Development Team Review Comments

Commenting Division: Plan Coordination 2nd Review

BERKELEY CENTER SUBDIVISION
CONSTRUCTION DOCUMENTS
FEDERAL BLVD. & W. 64TH AVE.
 DEMOLITION PLAN

SHEET 2 OF 3

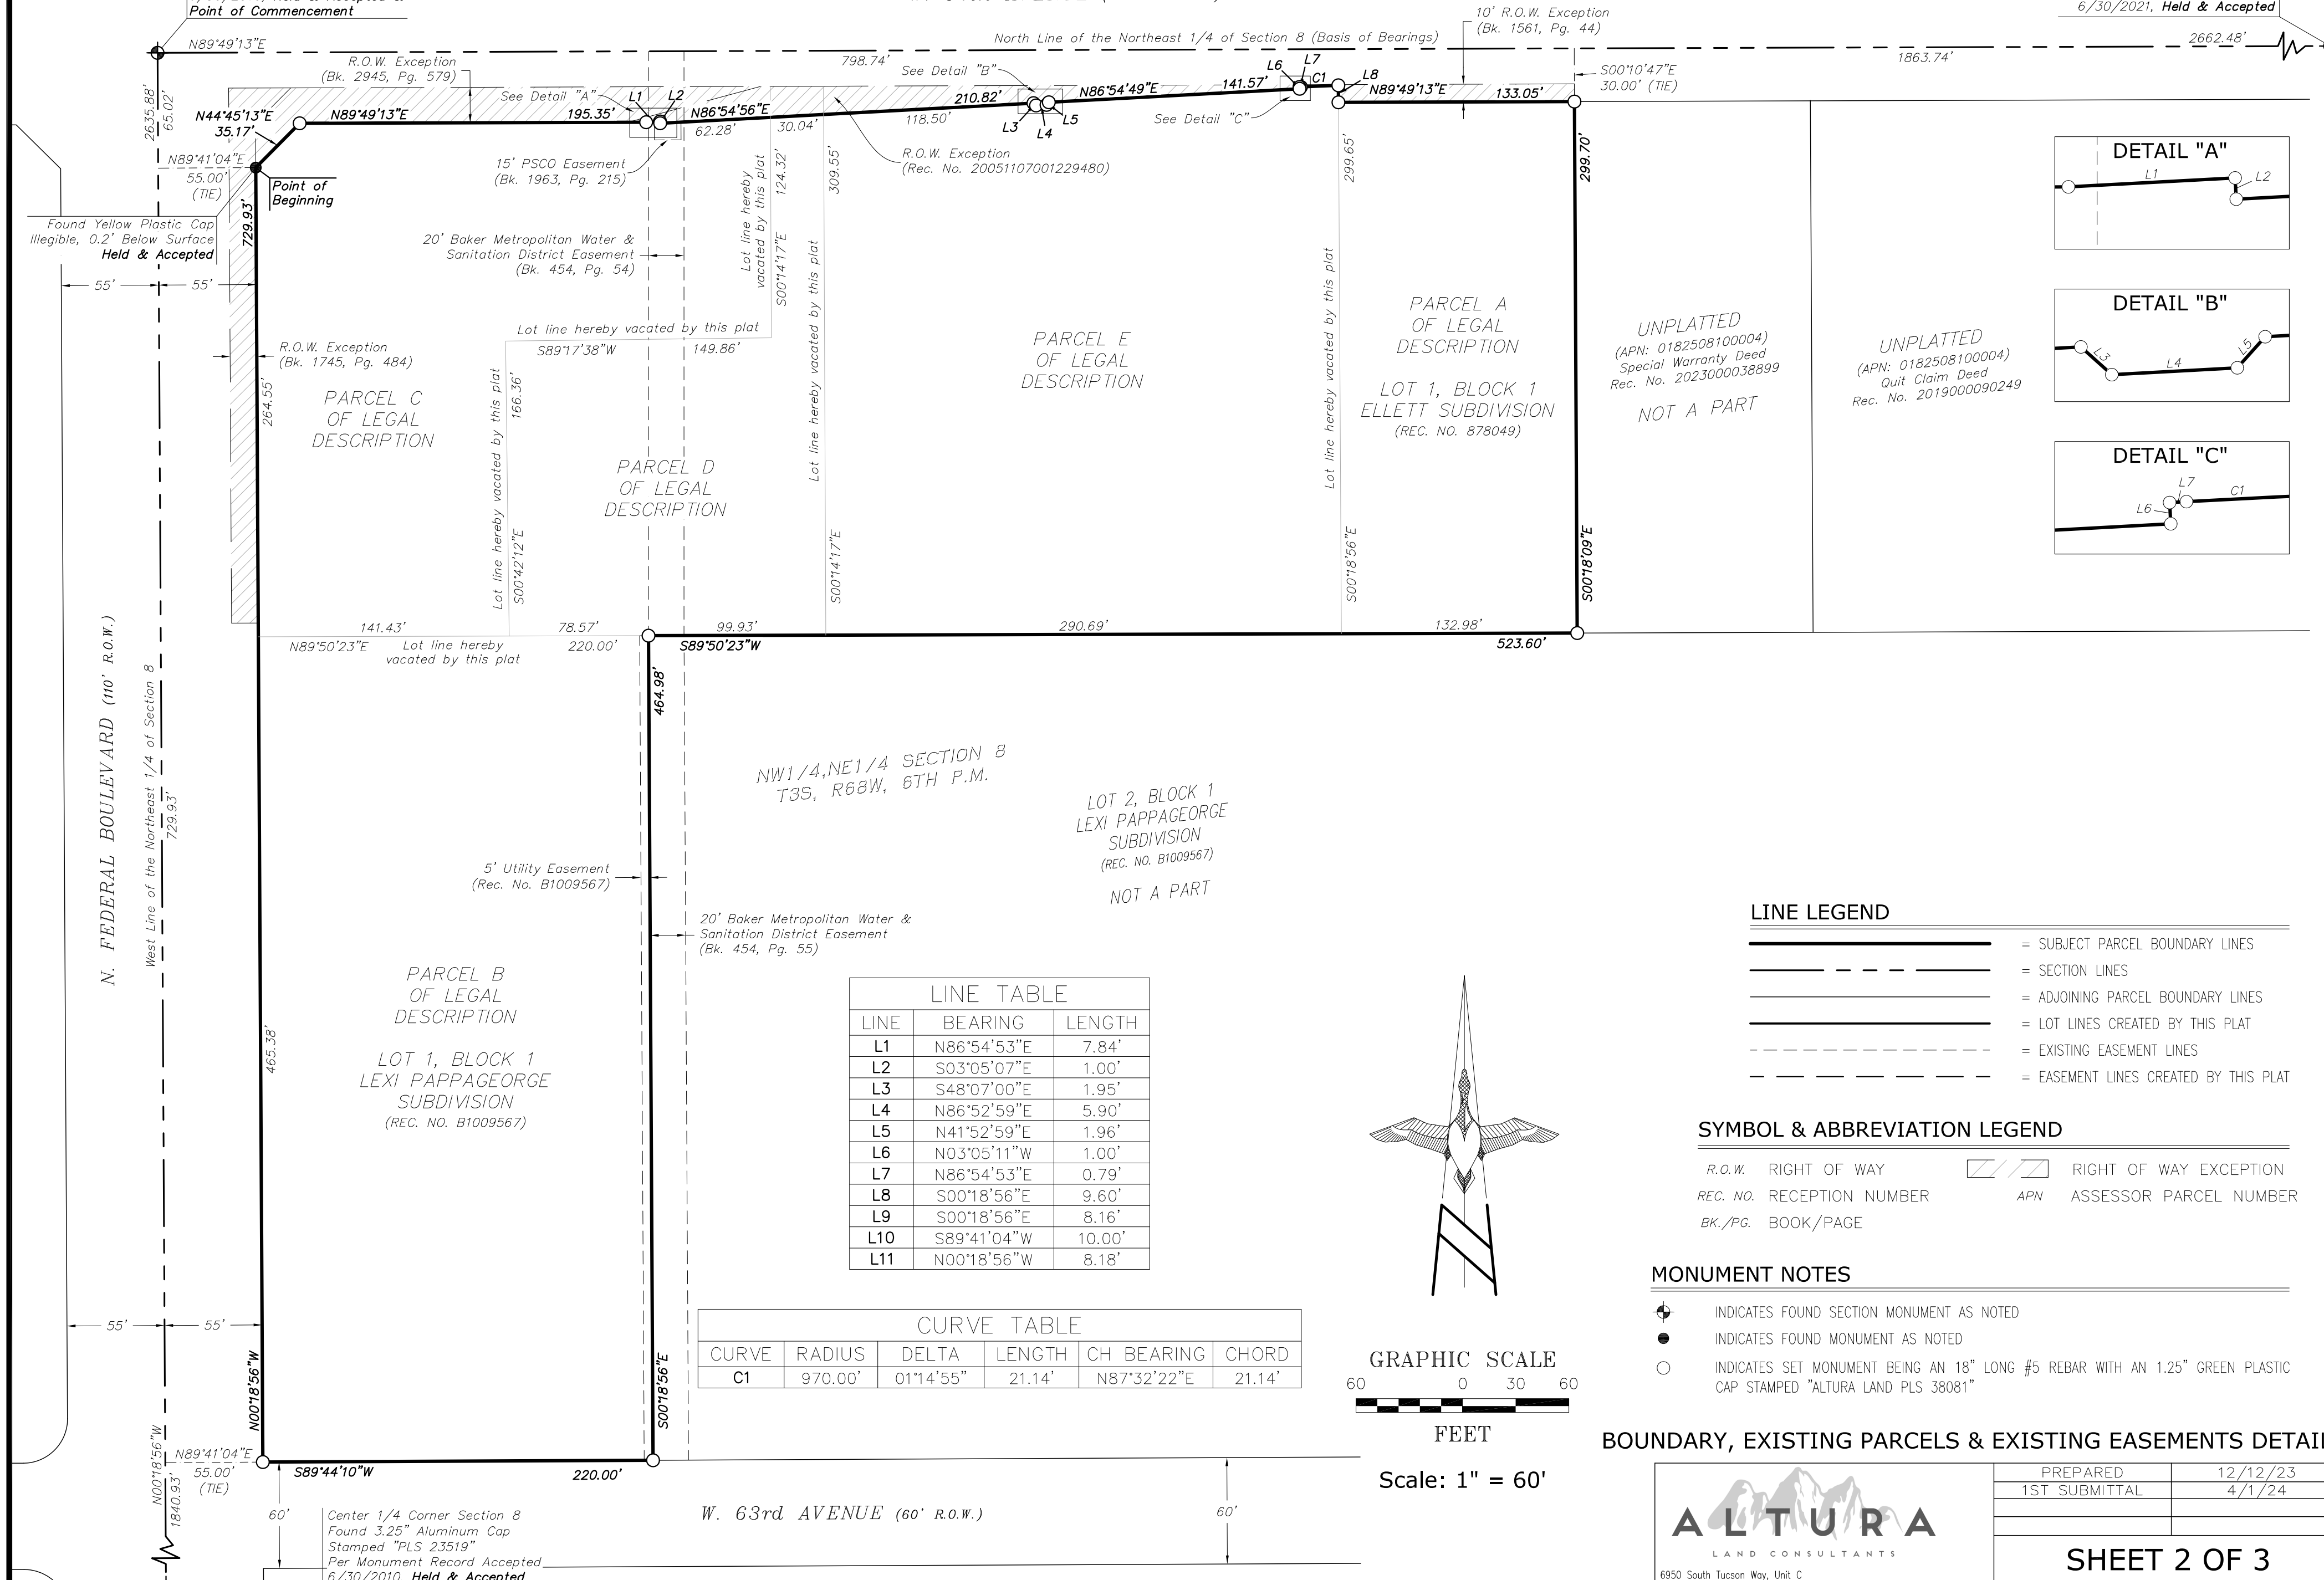
ROW13: Sheet 2 is the existing conditions and parcel lines. Do not provide where the new lots are to be located on this sheet. These parcel lines must be vacated. The parcels must be referenced as to the legal descriptions provided on sheet 1. You must state parcel lines being vacated by this plat.

SHEET 3 OF 3

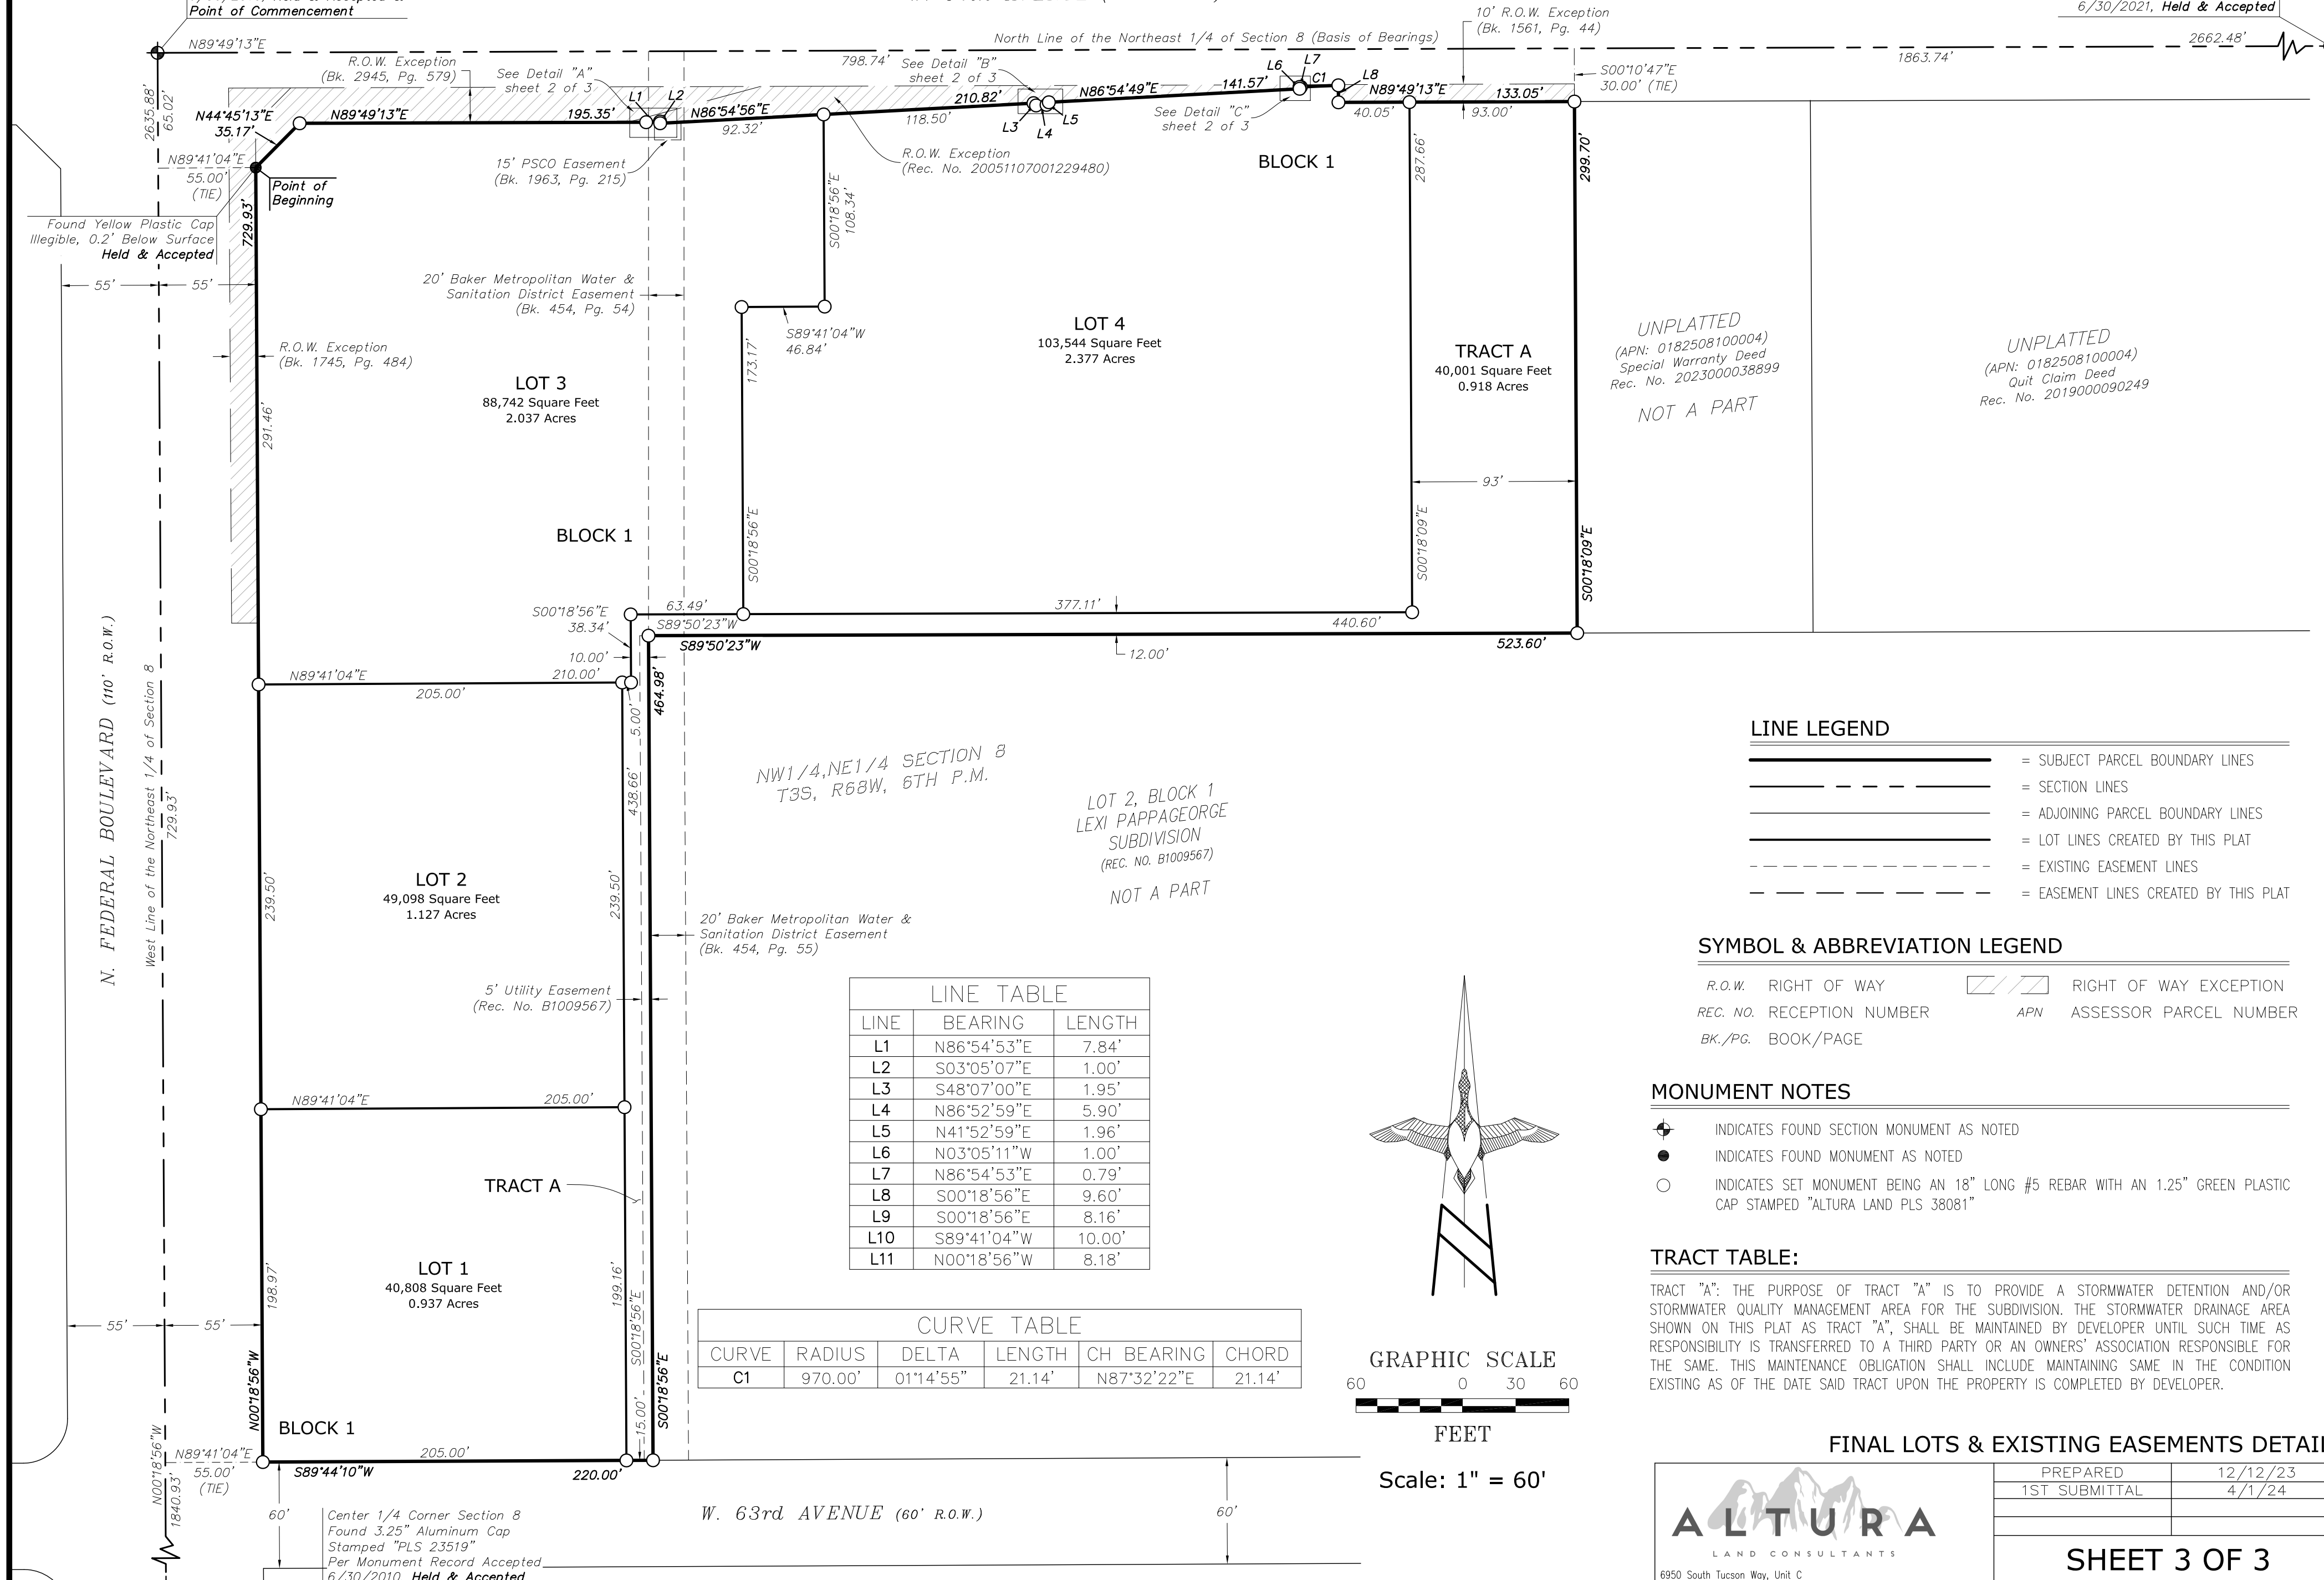
ROW6: Define the use of the tract on sheet 3. **KH RESPONSE: Updated.**

ROW15: The easements that appear to be missing cannot be vacated by this plat and must remain in place. If needing to vacate these easements, it will be an agreement between the property owner and the owner of the utility easement. Once the vacation has been completed and recorded, cite the vacation reception number. If utilities are installed it will be at the owners expense to move these utilities and provide a new easement. The easement/ROW document cited above is exclusively for sanitary sewer. It can be crossed, but nothing can share the trench. Does the 9' wide drainage easement being dedicated about the 5' wide utility easement as recorded at B1009567? The new one cannot lay on top of the existing.

SHEET
C002

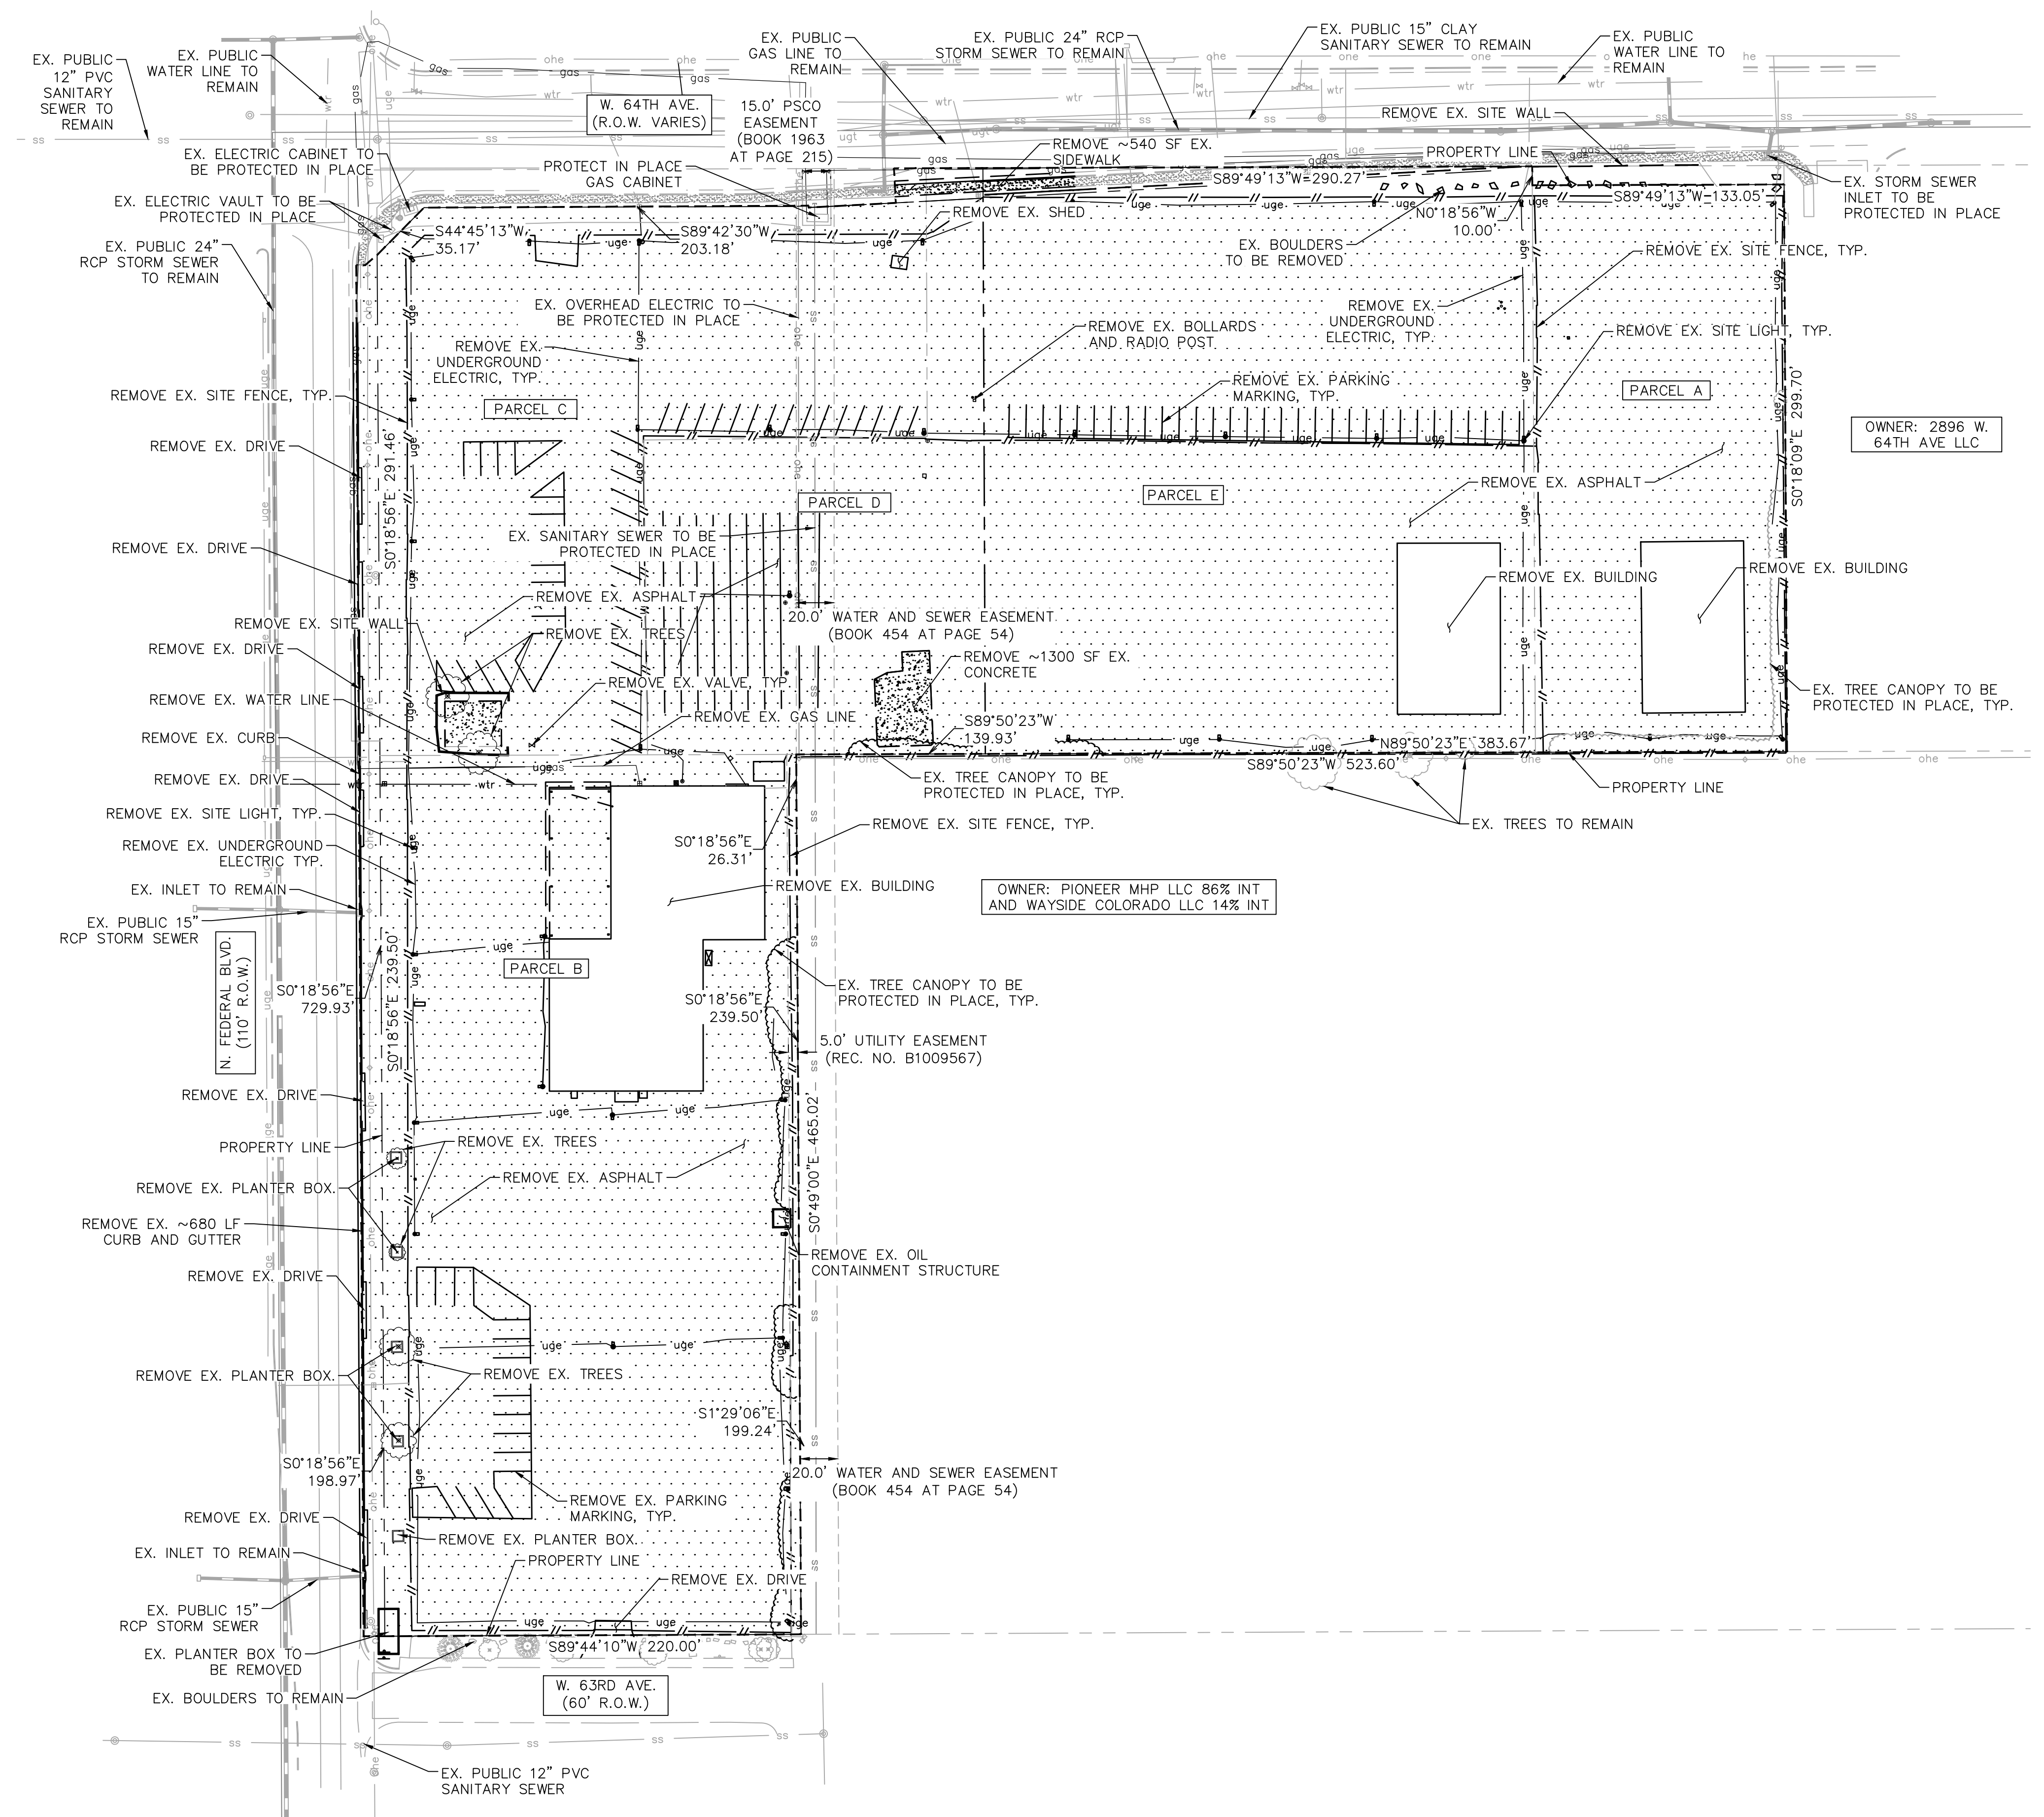
Add this note to the plans: "Any and all work within CDOT right-of-way must be performed according to the standards set forth in the latest editions of the CDOT M&S Standard Plans and Standard Specifications for Road and Bridge Construction." **KH RESPONSE:** Note added to plans on sheet C002 section General Notes.
